Replacement Distributor Cap on MerCruiser MPI Engines With HVS Ignition Systems

Models Covered	Serial Numbers
All MerCruiser V8 engines with HVS ignition systems	0M300000 and above

48515

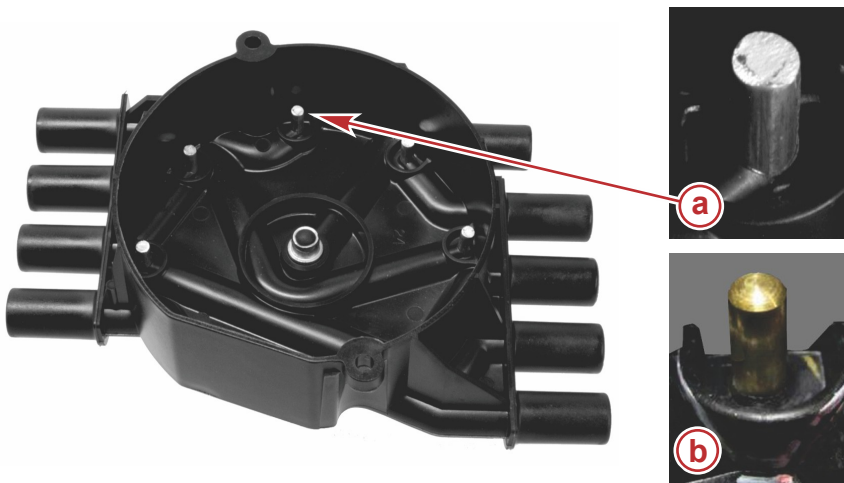
- a -** Good: Distributor caps with aluminum conductor (silver color)
- b -** Needs to be replaced: Distributor caps with brass conductor (gold color) and box dates between January 1, 2011, and May 24, 2011, only.

MerCruiser has received reports of a misfire condition occurring after recent installation of service replacement distributor caps that have brass conductors. The misfire typically begins to occur after 20 minutes of engine operation.

For parts already installed: Replace the part and file a warranty claim for parts and labor (see **Warranty** below).

For parts not installed but in dealer inventory: If the box date code is between January 1, 2011, and May 24, 2011, and the distributor cap uses brass conductors, file a warranty claim for parts only.

Original	New Part Number
898253T22 Cap	884792
898253T29 Cap and Rotor Kit	8M0060495
